**STAFF RECOMMENDATION**

**1013 Paris Avenue**  
**August 19, 2020**

**Application:** Violation; New Construction – Addition  
**District:** Waverly-Belmont Neighborhood Conservation Zoning Overlay  
**Council District:** 07  
**Base Zoning:** R8  
**Map and Parcel Number:** 118010242.00  
**Applicant:** Paul Martin, Contractor  
**Project Lead:** Sean Alexander, sean.alexander@nashville.gov

Figure 2: Site plan for a approved addition at 1013 Paris Avenue with new construction in red.

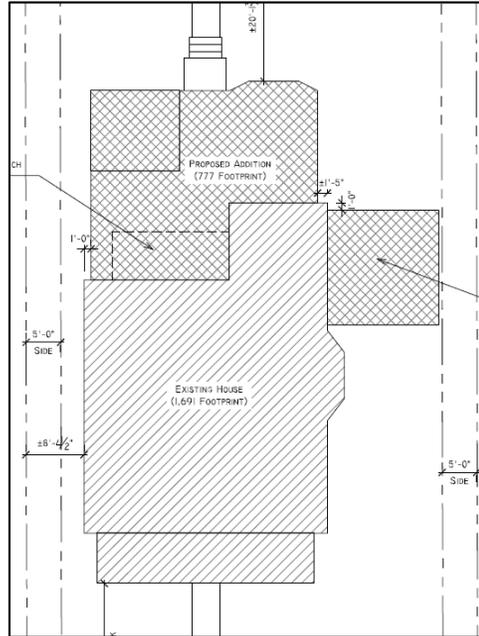
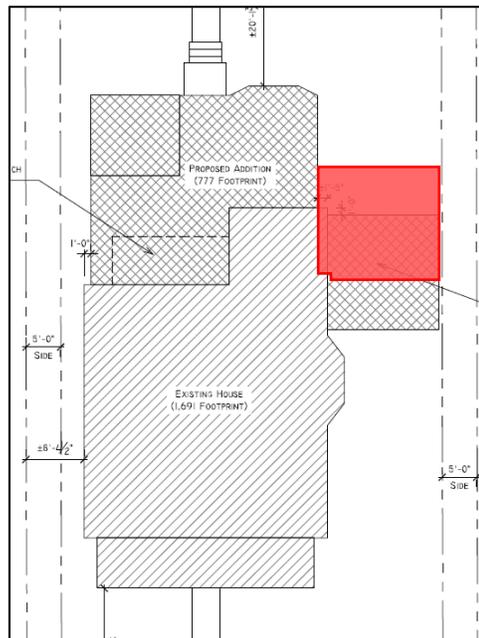
On July 23<sup>rd</sup>, 2020, MHZC Staff observed that construction had started again at 1013 Paris Avenue, for which no new plans had been reviewed and no new Historical Commission Permit had been issued. The construction includes a covered porch that connects the side and rear additions, wrapping the corner, with a masonry chimney.

**Recommendation:** Staff finds that the unapproved covered porch is not appropriate because it wraps the corner continuously, which is inconsistent with previous MHZC approvals and does not meet sections IV.A.1 and IV.A.2. of the design guidelines for rear and side additions.

Staff recommends that the unpermitted porch shall be removed within sixty (60) days.
